## Accessibility Site Visit Report - HC - ANSI

<b>Project Name</b>	Sample Property
<b>Visit Type</b>	3rd
<b>Date of Inspection</b>	02-12-2020
<b>Inspector</b>	Brian White
<b>Site Visit Accompaniment</b>	Jason Pendly
<b>Street Address</b>	123 Main St
<b>City</b>	Greenville
<b>State</b>	South Carolina
<b>Zip Code</b>	29605
<b>Accessibility Codes for this project (Check if used)</b>	2010 ADA, ANSI A117.1, UFAS
<b>Number of Buildings</b>	1
<b>Total Number of Units</b>	80
<b>Number of HC Accessible Units</b>	5
<b>Number of A/V Units</b>	0
<b>Number 1 Bedroom Units (Std/HC)</b>	80/5
<b>General Project Notes:</b>	NOTE – Element Findings at Time of Inspection: This inspection report indicates individual elements as Yes, No, or N/A. Each

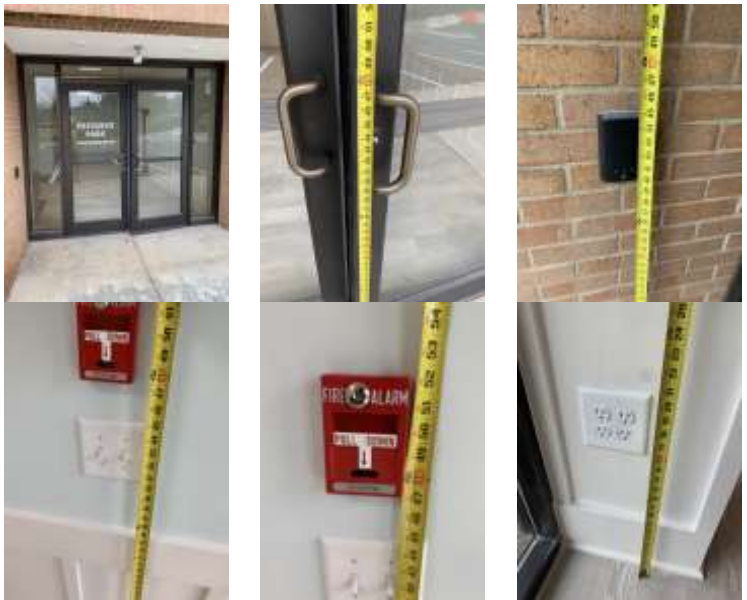
Status of this area	Finished stage
Doorway has a clear opening width 32" min. (ADA 404.2.3)	Yes
Threshold less than 1/2" with bevel or 1/4" no bevel (ADA 404.2.5)	Yes
Interior signs mounted (latch side) have tactile characters (measured from the baseline) between 48" min. - 60" max. (ADA 703.4.1)	Yes
Interior sign characters at least 5/8" but no more than 2" tall (ADA 703.5.5)	Yes
Electric switches/outlets 44" max. AFF over workspace others behind counter 46" max. AFF (ADA 308.2.2 (b))	Yes
Kitchen counters 34" max. AFF (ADA 804.3.2)	Yes
Top lip of kitchen sink 34" max. AFF (ADA 606.3)	Yes
Kitchen sink has 27" knee clearance, 30" clear width, and 9" min. height toe clearance (ADA 306)	Yes
Are drain and water supply pipes insulated or covered by skirt (ADA 606.5)	Yes
Faucet controls Lever Handle style or easy to operate (ADA 309.4)	Yes
Pass through kitchen has 40" min. clear width (ADA 804.2.1)	Yes
At least 50% of shelf space within 48" max - 15" min AFF (ADA 804.5)	No

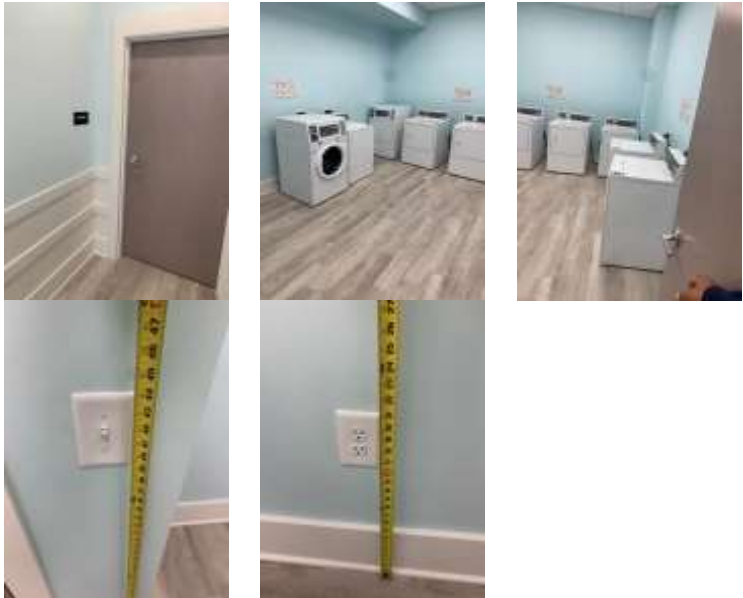
<b>Location of Fitness Center</b>	Basement
<b>Status of this area</b>	Finished stage
<b>Interior signs mounted (latch side) have tactile characters (measured from the baseline) between 48" min. - 60" max. (ADA 703.4.1)</b>	Yes
<b>Interior sign characters at least 5/8" but no more than 2" tall (ADA 703.2.5)</b>	Yes
<b>Doorway has a clear opening width 32" min. (ADA 404.2.3)</b>	Yes
<b>Threshold less than 1/2" with bevel or 1/4" no bevel (ADA 404.2.5 UFAS 4.13.8)</b>	Yes
<b>12" min. clearance on push side of the door (with door closure) (ADA 404.2.1)</b>	Yes
<b>Does the door take at least 5 seconds to close (2010 ADA 404.28.1)</b>	Yes
<b>Electric switches 48" max. AFF and outlets 15" min. (unobstructed) (ADA 308.2.1)</b>	Yes
<b>Clear floor space of 30" X 48" provided at each type of equipment (this space permitted to overlap) (ADA 1004.1)</b>	Yes
<b>Fitness Center Photos</b>
